Exhibit D1

November 16, 2020

Re: 82-88 Fulton Street
New York, NY
Block: 77 Lot: 24

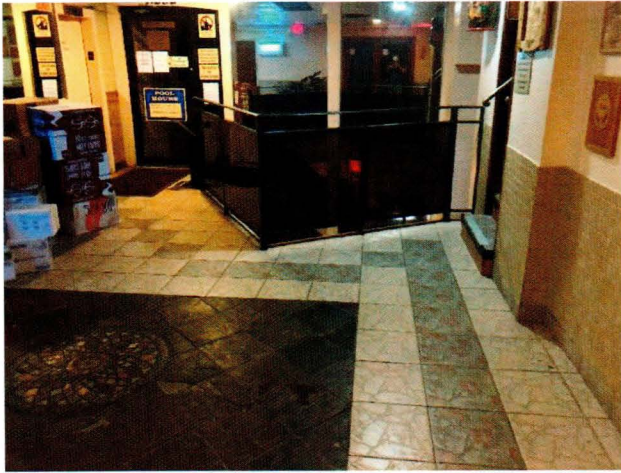
The next space which we looked at was a vacant Chinese restaurant. The approach, Into the space does not meet ADA requirements. Since the front entry door Is considered a

side approach, the walkway needs to be 42" wide minimum, but the current passageway or balcony Is only 36". In terms of the Interior, the space was vacant, with no public restroom or tables setup.

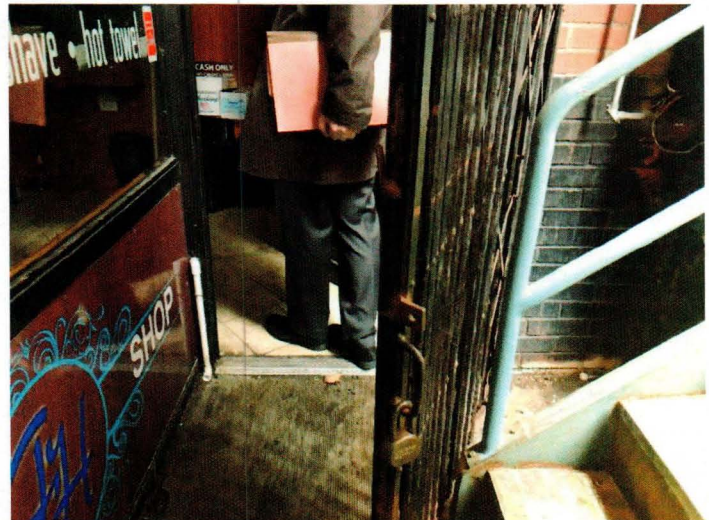
The sixth space which we looked at was a vacant retail space located on basement level

of the building. Like the other retail space, the basement level is not ADA compliant also, with access by stairs only. Since the space was vacant, an inspection of the interior was not conducted, since the ADA issue should be taken care of by any future tenant build out, when filing for work inside.
